APPLICATION NUMBER: 25/0700

PROPOSAL: RESIDENTIAL DEVELOPMENT INCLUDING THE ERECTION OF 32NO UNITS, ACCESS, CAR PARKING, ENGINEERING, LANDSCAPING AND ASSOCIATED WORKS

SITE: Land formerly The Open Hearth, Hendre Farm Drive, Newport NP19 9LH

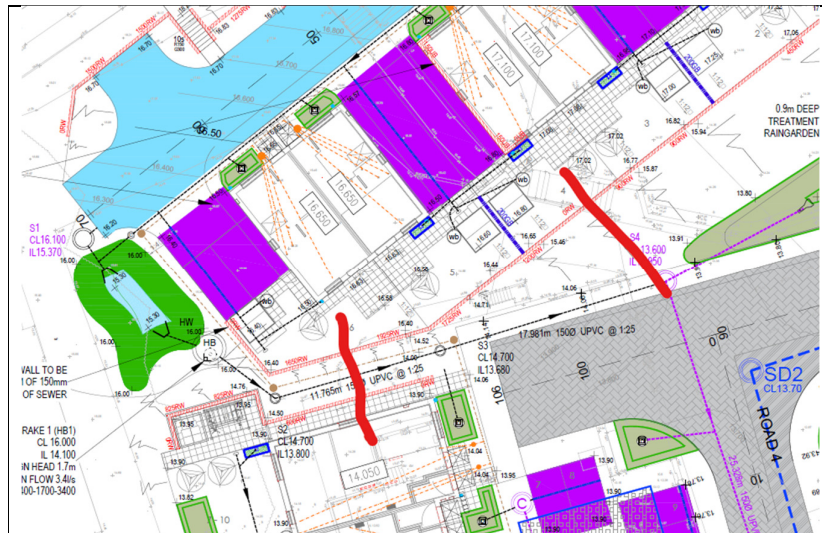
1. The planting plan should show easement constraints to tree planting, and at least top and bottom of slope levels as shown on the Site Plan by Le Trucco along with confirmed gradient for steep grass slope banks.
2. Grass maintenance to steep slopes needs some assessment from a H&S point of view. Grass slopes often end with retaining walls, some upstand or rail will be needed, this would include for example retaining walls around visitor parking and bin stores along Hendre Drive boundary.
3. Retaining walls south of plots 1-6 have retaining walls of up to 1.9m, are these topped by a 1.8m timber fence as shown on the boundary plan? Sections by the landscape consultant are needed to show the detail including hedge planting or grass, suggested section lines are shown below.
